**Request for Additional Information – Siemens Power Corporation Topical Reports,
EMF-2310(P) Revision 0, (TAC No. MA7192) and EMF-2328(P) Revision 0, (TAC No. MA8022)**

S-RELAP5 Request for Additional Information (RAI)

The following are in regard to EMF-2100(P) Rev. 2:

Figure 1. Comparison of energy error between S-RELAP5 and RELAP5/MOD2 energy equations

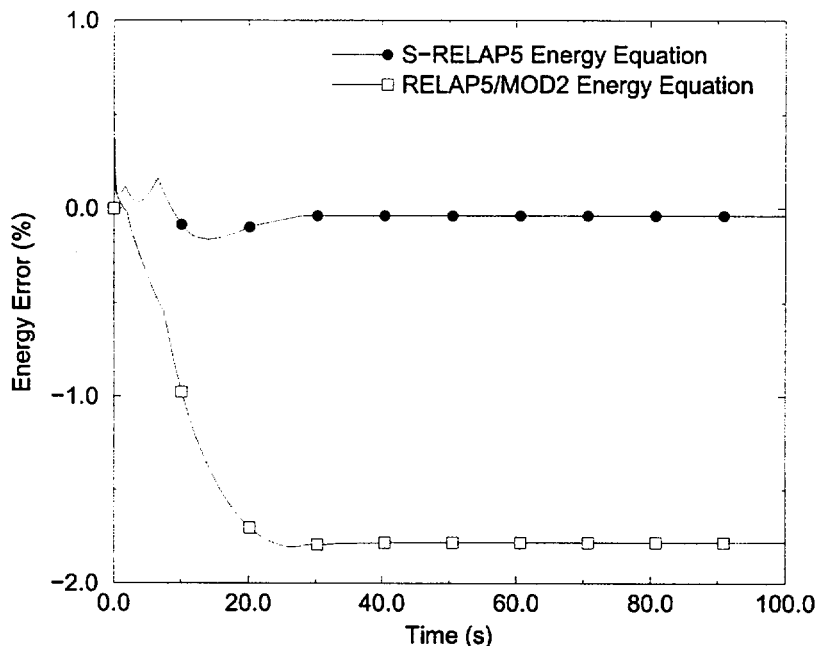
2.6 *On Page 2-6 you stated that under most circumstances, assessment calculations indicate that there are essentially no differences in the results of key loss of coolant accident (LOCA) parameters between the RELAP5/MOD2 energy equations and the energy equations provided in S-RELAP5. Please provide a discussion of the assessment calculations performed including a discussion of the key LOCA parameters that were assessed. In addition, please provide a discussion of the circumstances where differences were identified and justify your methodology in light of those differences. Also, provide similar discussions related to the other transients that you are proposing to analyze with the code.*

A demonstration calculation can be made to show the energy error when using the S-RELAP5 energy equations compared to the RELAP5/MOD2 energy equations. Consider a closed system where potential and kinetic energies are negligible and consisting of a small diameter pipe (1 m) at high pressure (150 bar) blowing down into a large diameter pipe (10 m) at low pressure (1 bar) through an orifice. Since there is no change in total internal energy in a perfect system, a comparison of initial internal energy to the transient internal energy during the blowdown should indicate net internal energy error.

A calculation of this type was made with both S-RELAP5 and ANF-RELAP (ANF-RELAP uses RELAP5/MOD2 energy equations). The results in Figure 1 show that energy is conserved to within 0.04% by S-RELAP5 while ANF-RELAP shows an error of approximately -2%. These results imply that there will be a much smaller energy error when transferring energy out of a system (i.e., coupled primary and containment calculation) using S-RELAP5 compared to a code using the RELAP5/MOD2 energy equations.
